Our Ref: RG/RG/G267/L001
Date: 15th February 2024

APPLICATION REF: 21/00744/FUL
KIRKBY VALLEY GOLF COURSE, INGOE LANE / VALLEY ROAD, KIRKBY

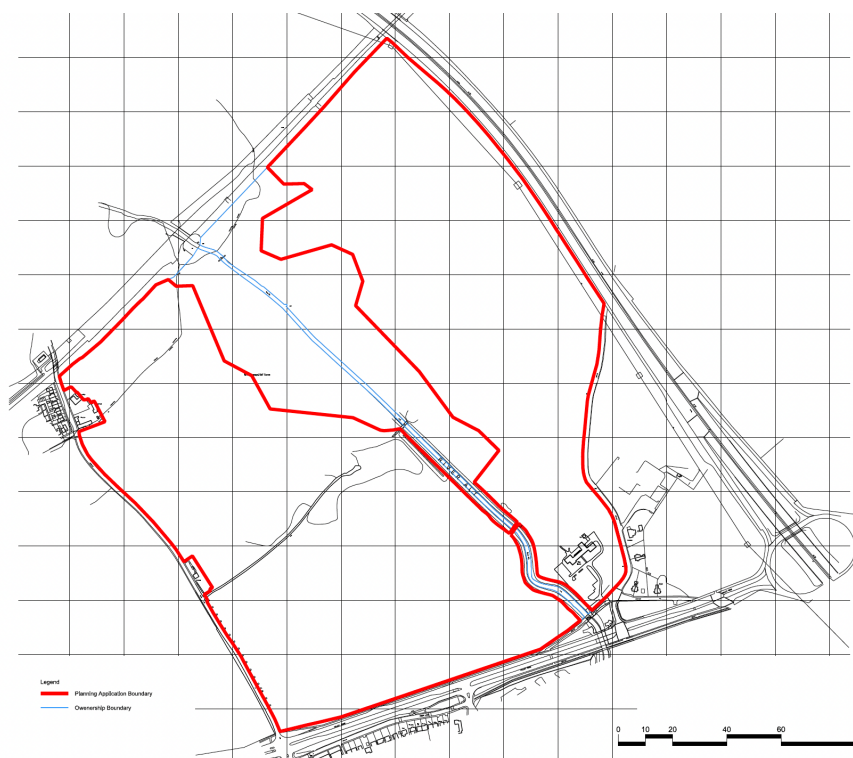
The River Alt was realigned and there is a landfill on site (assumedly associated with some earthworks). The development will require a full contaminated land condition with gas monitoring within the location of the proposed buildings. The material proposed to be brought on to site will need to be from a reputable civils supplier. All material must be suitable for reuse and in line with current waste legislation.

There is no work close to the river, aside from the erection of a small footbridge to enable golfers to access the course (the details of which were submitted with the original application details).

Beyond that, there are no proposed works near the water course (refer to the red line boundary which confirm this point – see extract below).
